Addendum No. 01

Subject: William H. Hunter ES – Classroom Modernization
SDP Contract Nos. B-055C, B-058C, of 2017/18

Location: WH Hunter ES
2400 N. Front St.
Philadelphia, Pennsylvania 19133

H INTERIOR ELEVATION H
1/4" = 1'-0"

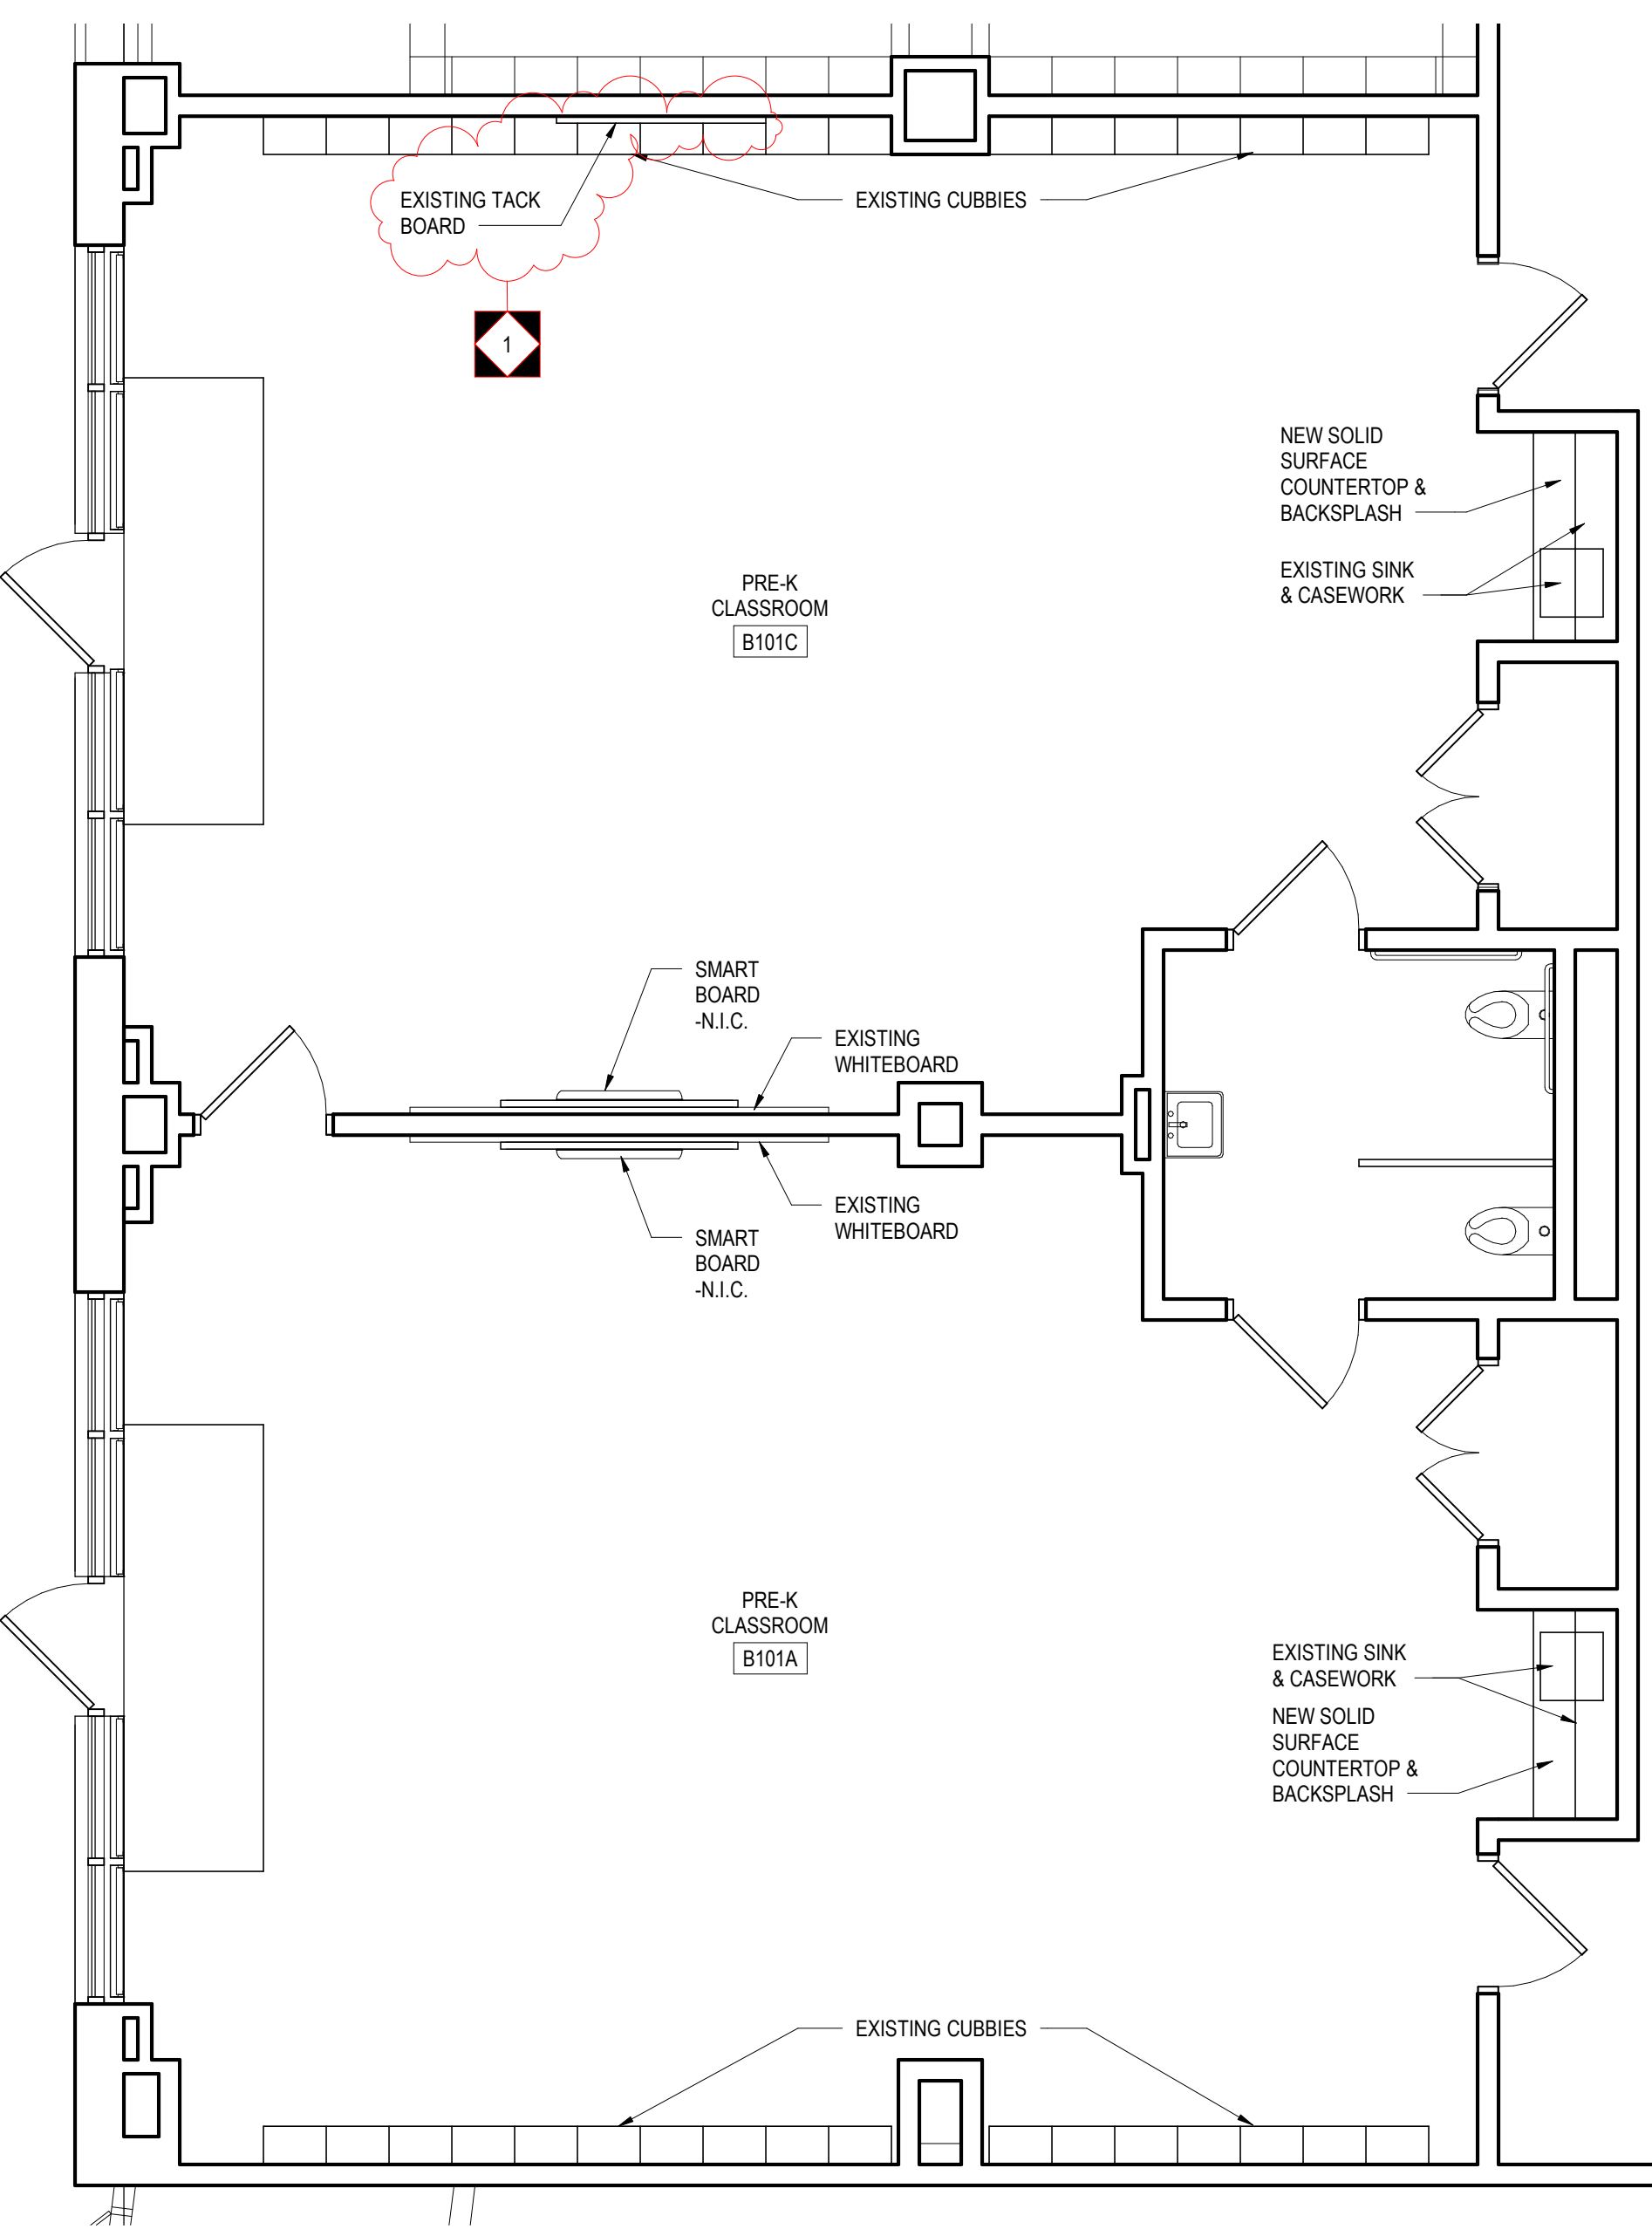
1. **REVISE** 702 marker board to 709 tack board.
2. **ADD** existing tack board.

E112A

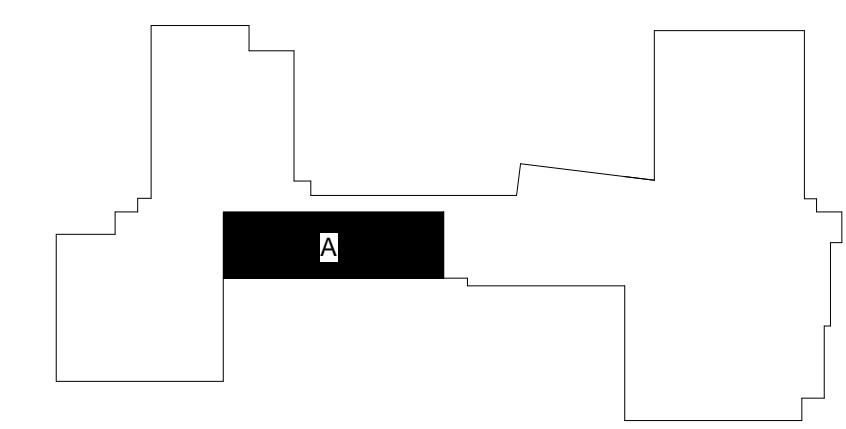
1. **REVISE** Indicate location of IDF room 220.
